<b>AMENDMENT OF SOLICITATION / MODIFICATION OF CONTRACT</b>			1. Contract Number DCKA-2014-B-0023	Page of Pages 1   8
2. Amendment/Modification Number A03	3. Effective Date See 16C	4. Requisition/Purchase Request No.	5. Solicitation Caption 16 <sup>th</sup> Street Bridge

Solicitation No. DCKA 2014-B-0023

Rehabilitation of 16th Street Bridge over Military

Road - Pre Bid Questions

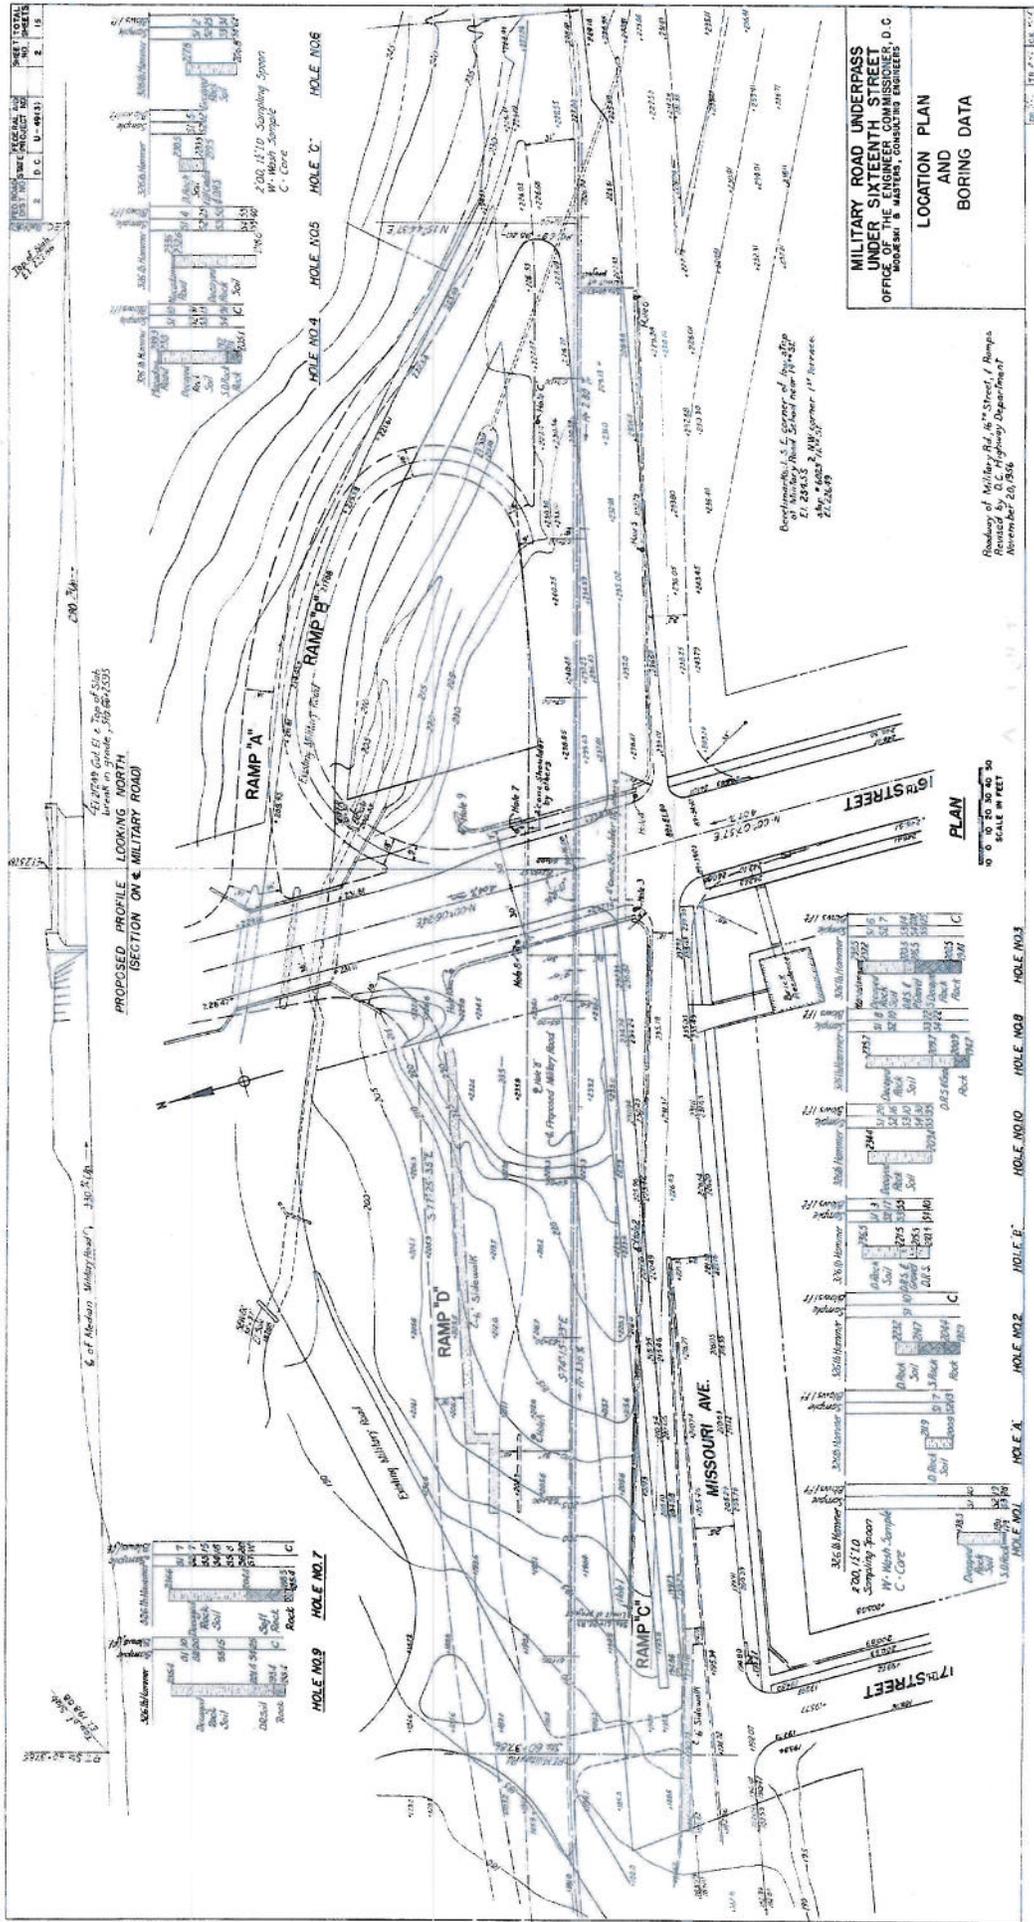
Q1. The boring log information for hole #7 and hole #9 is not found in the boring log information sheets. Where can we get that information?

A1. DDOT Response: This information can be found in the informational drawing. Since the scanned document missed Hole #9, please see the Location Plan and Boring Data sheet in this Amendment.

8A01721

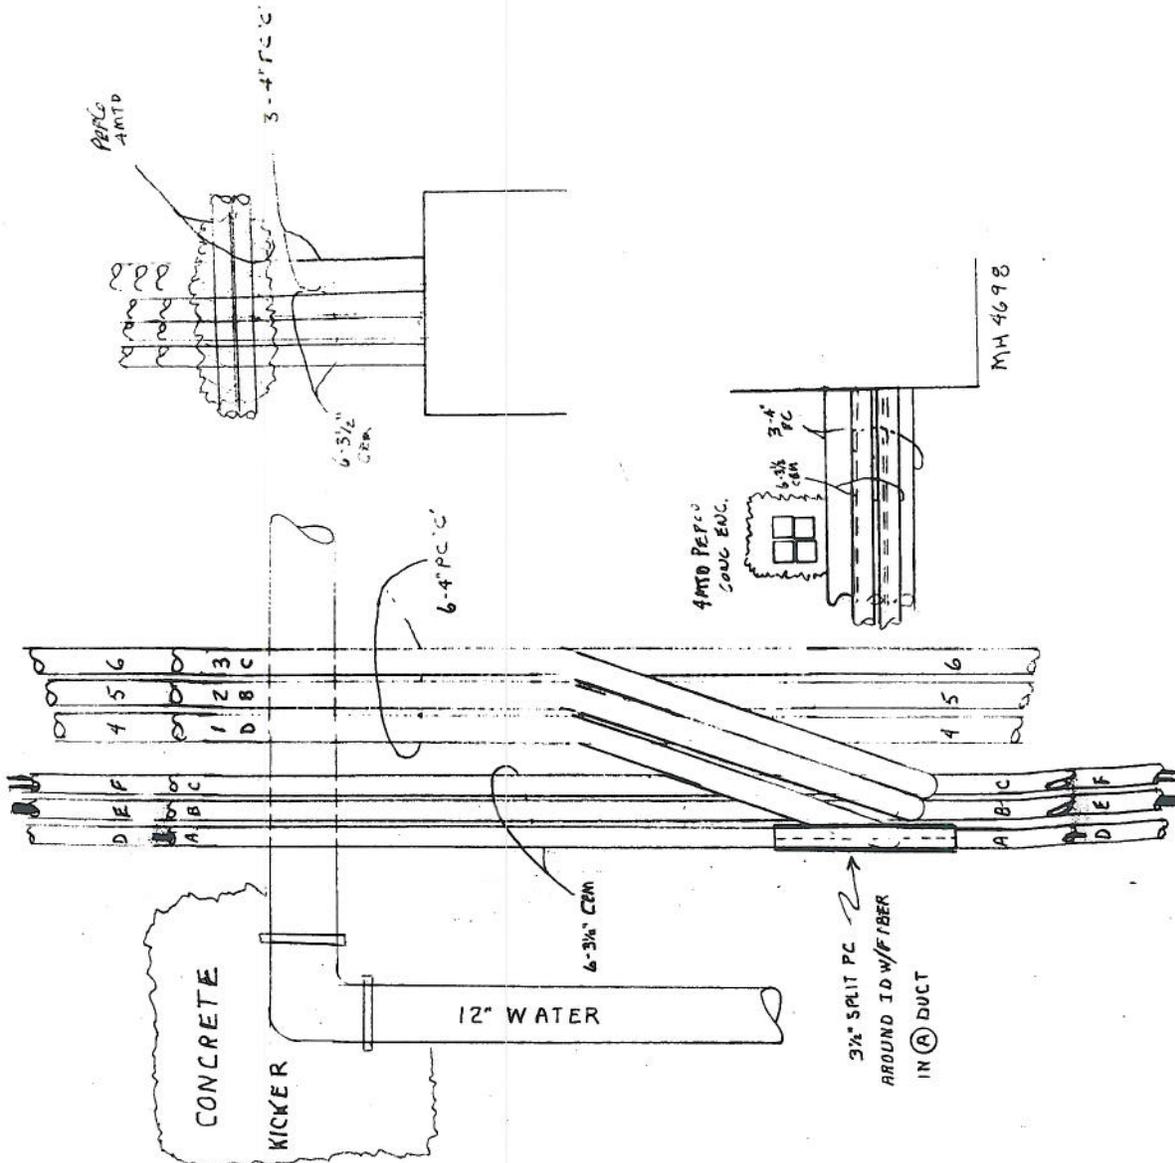
Q9. The Drawing from Verizon (as mentioned in the Special Provisions page105) showing the locations of their existing manholes 5275 and 5247 should be included as part of the Bid Documents. The two contract drawings 54A and 54B conflict.

A9. DDOT Response: See the contract plan sheet 52A for Verizon information and contract plan sheet 52B for Guard Rail Details. See Verizon Drawing PROJ: 7A00619.
